DESCRIPTIVE REPORT

Field No. LJ-10-4-60 Office No. H-8542

Locality Crescent Harbor & Saratoga Passage

HYDROGRAPHIC SURVEY REVIEW

ADDITIONAL WORK (1962)

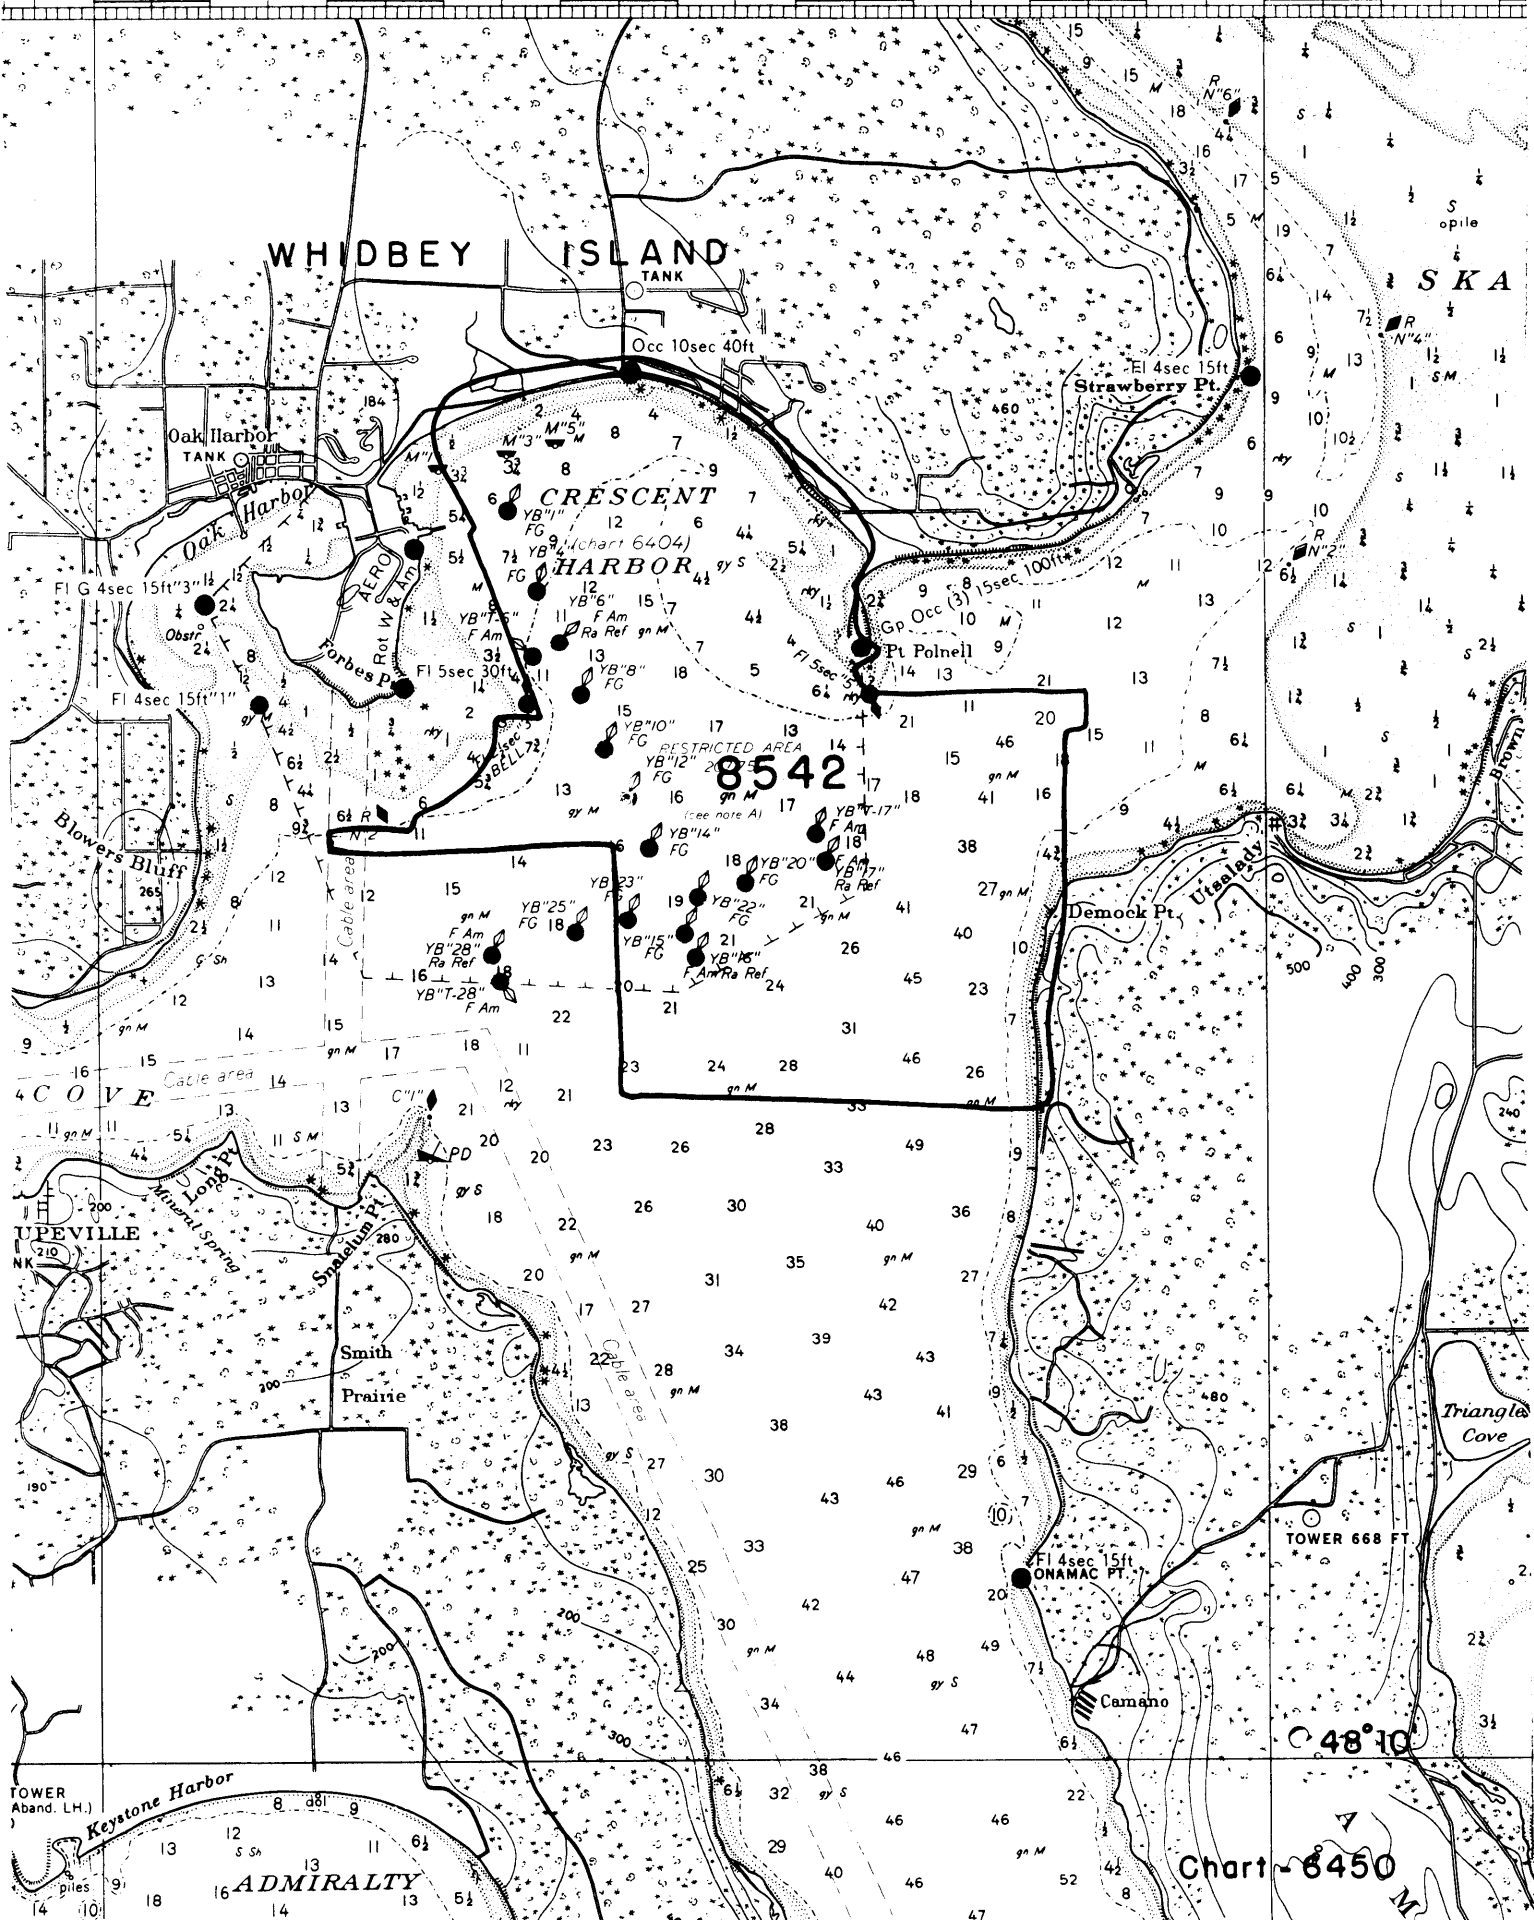
This survey has been compared with Chart 6450, 12th Ed., Nov. 6/61 and, except for one sounding that could not be verified, the agreement is good. The  $3\frac{3}{4}$  fm. charted sounding at Lat.  $48^{\circ}17'.47''$ , Long.  $122^{\circ}36'.44''$ . This sounding falls close to 5.3 fms. on the smooth sheet. See section of this chart attached to this report for comparison.

\* See Review Paragraph ~~3C~~ 3C.  $3\frac{3}{4}$  disproved.

- A. Depths at crossings are in good agreement.
- B. The usual depth curves are adequately delineated. The development of bottom configuration and determination of least depths are considered adequate.
- C. Additional development of an area centered at lat.  $48^{\circ}17'30''N.$ , long.  $122^{\circ}36'30''W.$  to disprove a charted  $3\frac{3}{4}$  fm. sounding was accomplished in 1962. The overlay for this additional work is included in the descriptive report.
